LATHAN
ARCHITECTS
LATHAN ■ BRYANT ■ CALMA

ADDENDUM NO. 2
ADDITION AND RENOVATION FOR FLOMATON ELEMENTARY SCHOOL
PACKAGE A: MEDIA CENTER AND CLASSROOM ADDITION
DCM NO. 2021011 PSCA NO. 9167
Architect Job No. 21-04A
March 29, 2022

The Plans and Specifications are hereby amended. The following supersedes all contrary and/or conflicting information and is made part of the contract documents.

SCALE: NONE

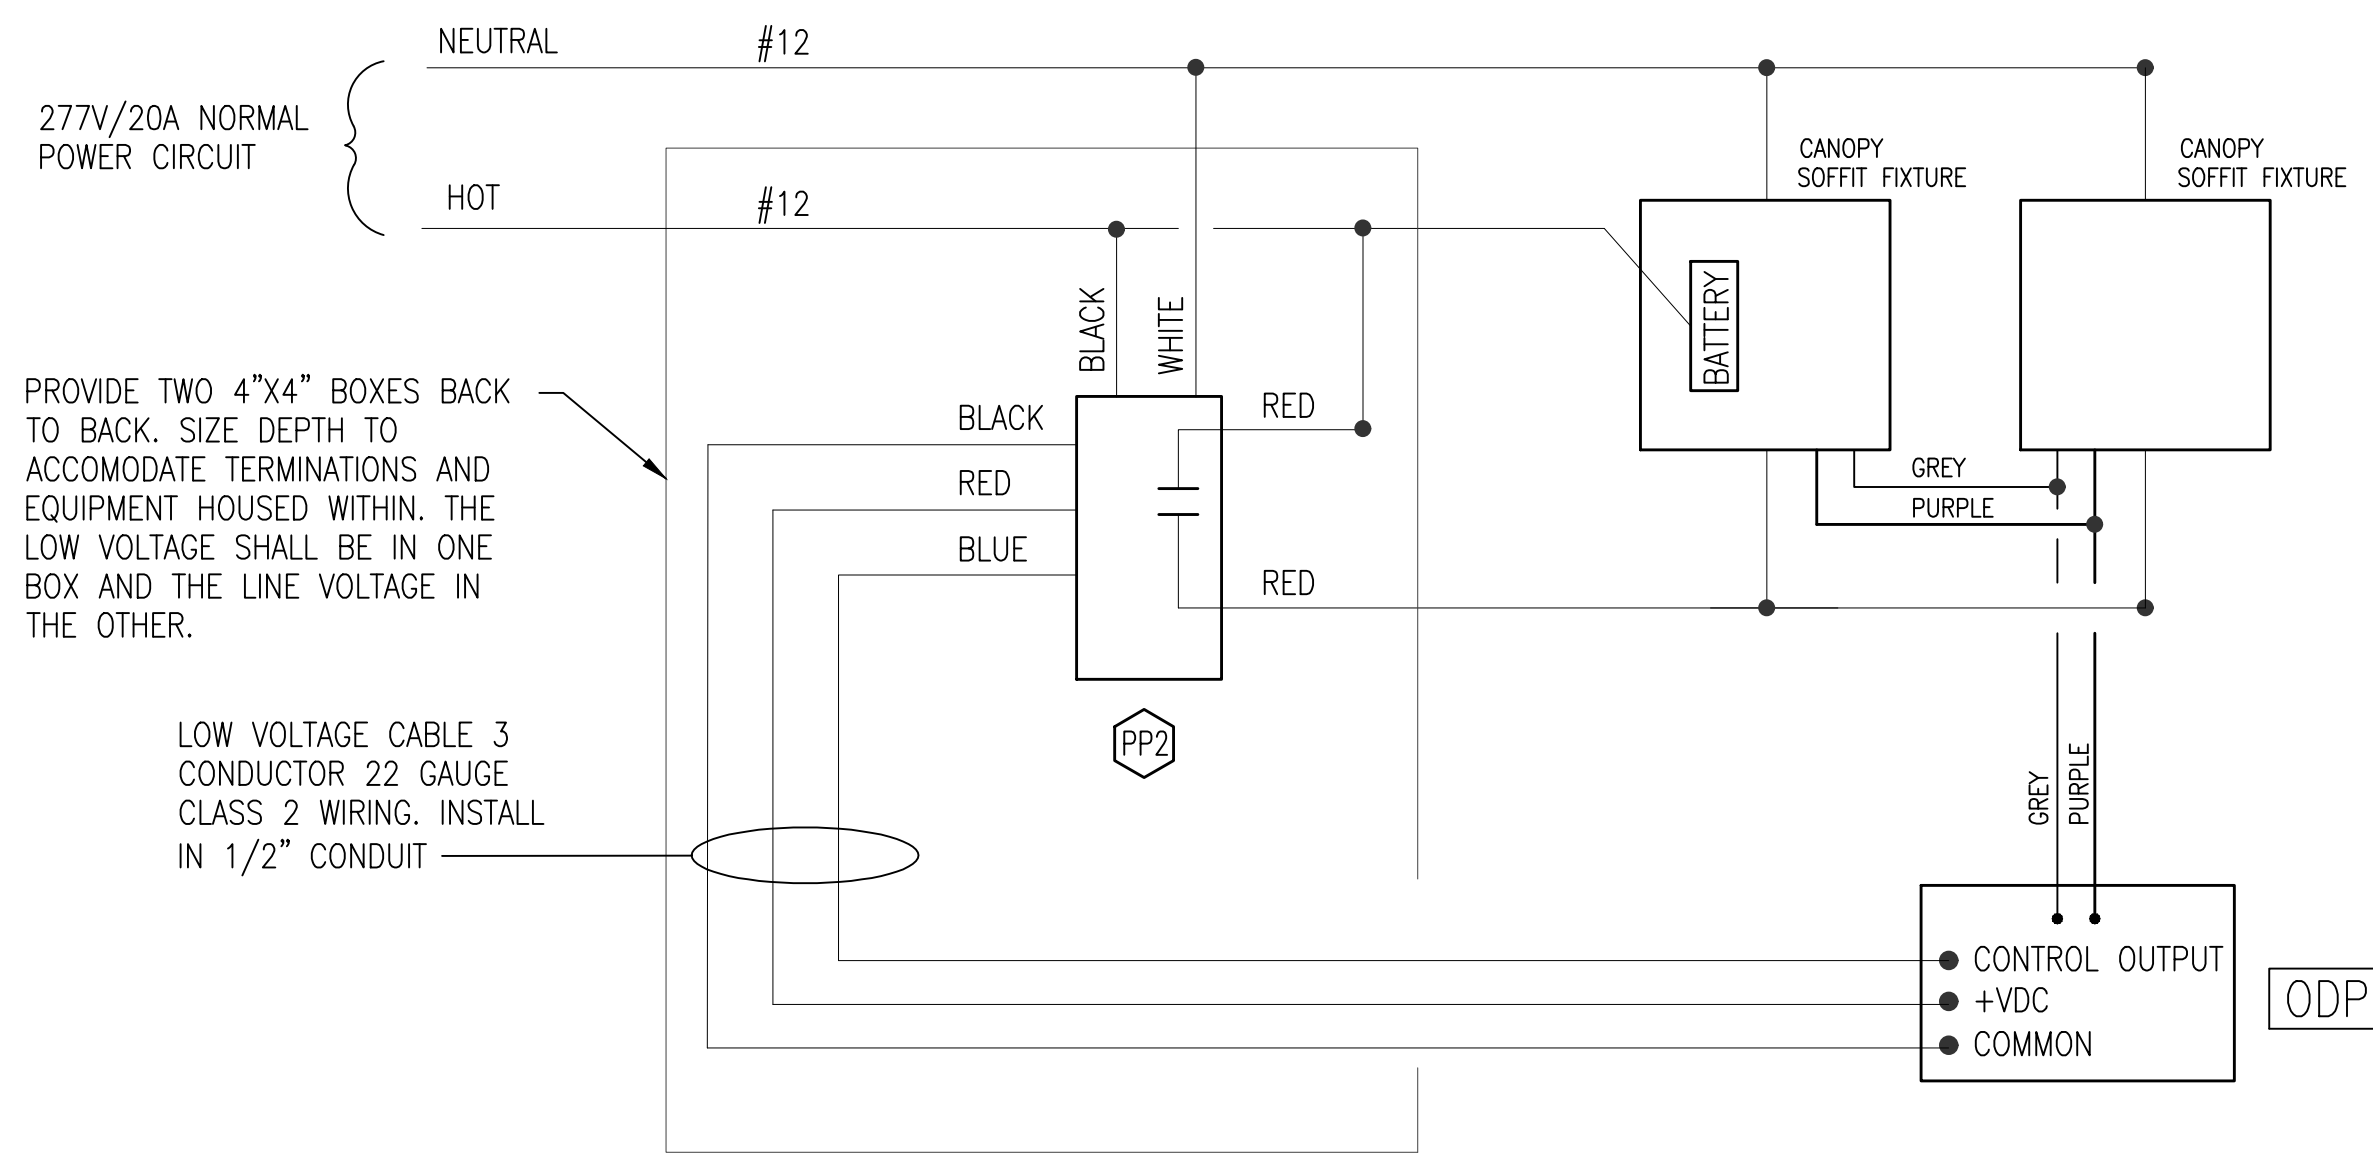
7. E4.1 – Electrical Details – see revised sheet.
8. E4.2 - Electrical Details – see revised sheet.
